Subject: Waterford 3 SES  
Docket No. 50-382  
License No. NPF-38  
Waterford 3 Cycle 10 Core Operating Limits Report

Please find attached Revision 2 of the COLR for Waterford 3 Cycle 10. In Revision 2, the restriction in Section 3.1.1.3 was modified to allow continued operation for the entire cycle; Figures 2A, 2B, and 2C were added; and Section 3.2.7, COLSS Out of Service power range, was modified to be consistent with the Technical Specifications.

#### REVISION 2

**COLR Figure 2A**

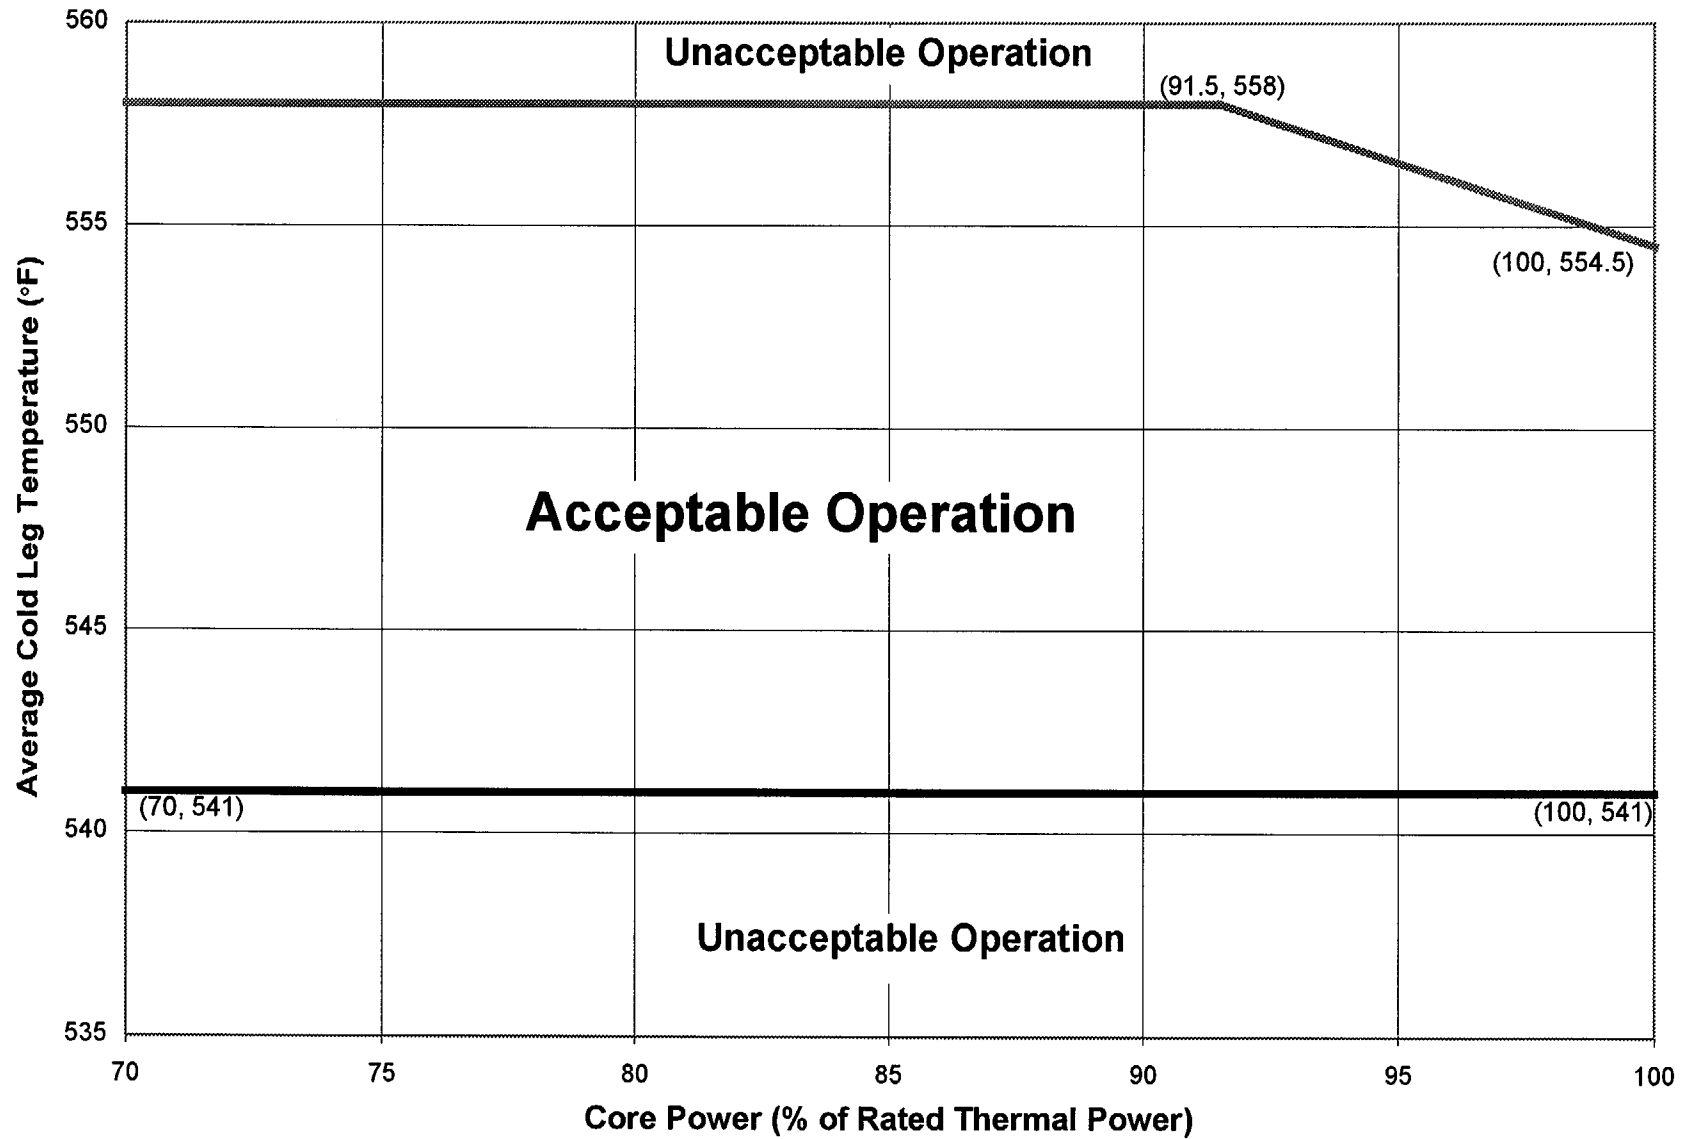
1. Modified Section 3.1.1.3 restriction to allow continued operation for the entire cycle.
2. Added Figure 2A, Figure 2B, and Figure 2C.
3. Modified Section 3.2.7 COLSS Out of Service power range to be consistent with the Technical Specifications.

- With the Critical Boron Concentration (CBC) less than or equal to 153 ppm and greater than 100 ppm, the COLR Figure 2A cold leg temperature and power restrictions shall be maintained within the region of acceptable operation.
- With the CBC less than or equal to 100 ppm and greater than 50 ppm, the COLR Figure 2B cold leg temperature and power restrictions shall be maintained within the region of acceptable operation.
- With the CBC less than or equal to 50 ppm, the COLR Figure 2C cold leg temperature and power restrictions shall be maintained within the region of acceptable operation.

**Cold Leg Temperature versus % of Rated Thermal Power**  
**Critical Boron Concentration (CBC) Less than or Equal to 153 ppm and Greater than 100 ppm**  
 (153 ppm ≥ CBC > 100 ppm)
